# E3634A-05C

# S E R V I C E N O T E

## E3634A DC Power Supply

**Metal Strap Kit for tightening loose bumper and for fitting rear lock link in side-by-side rack mounting**

Figure 1: Top view 3mm gap observed between two different chassis designs

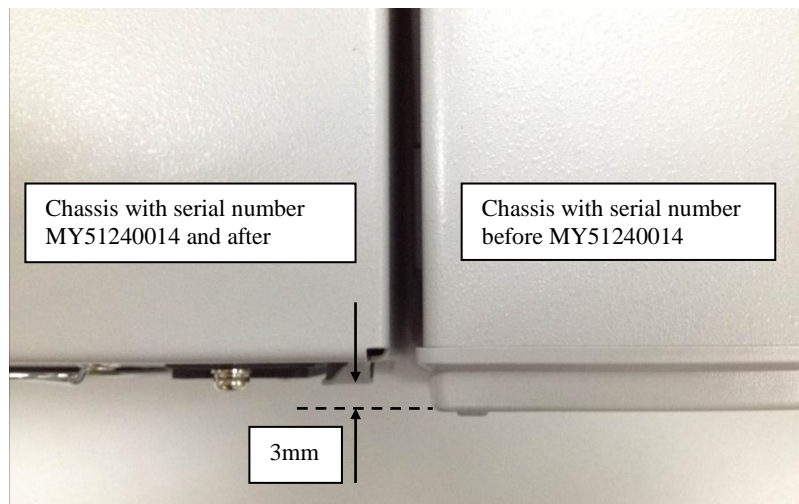
The chassis depth difference between the two designs is 3mm as shown in Table 1 and Figure 1 below.

Serial number range	Chassis depth
MY51240014 and after	345.2 mm
Before MY51240014	348.2 mm

Figure 2: Top view 3mm gap observed on rear lock link for side-by-side rack mounting

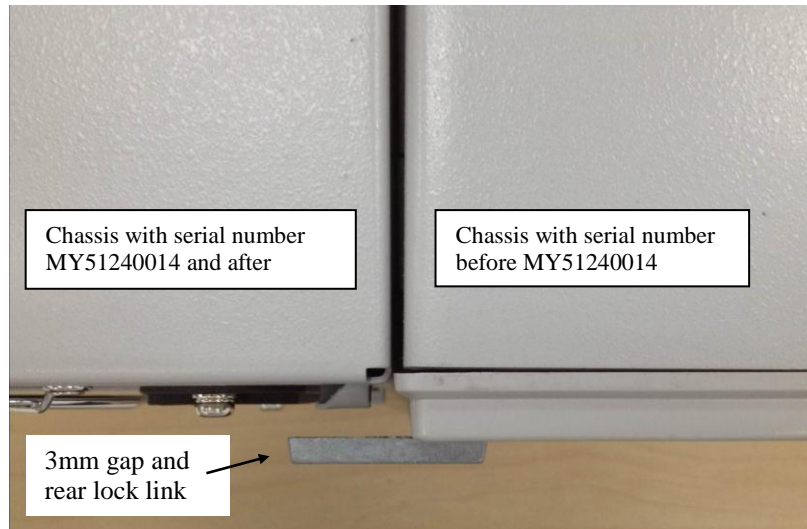
The 3 mm gap between the two different chassis may cause difficulties in securing them together using a rear lock link kit (part number 0050-2167) for side-by-side rack mounting as shown in Figure 2 below.

Use metal strap (part number E3631-07901), and stack the provided two metal straps together to form 3mm thickness and secure it with the provided screws on the rear lock link as shown in Figure 4 below.
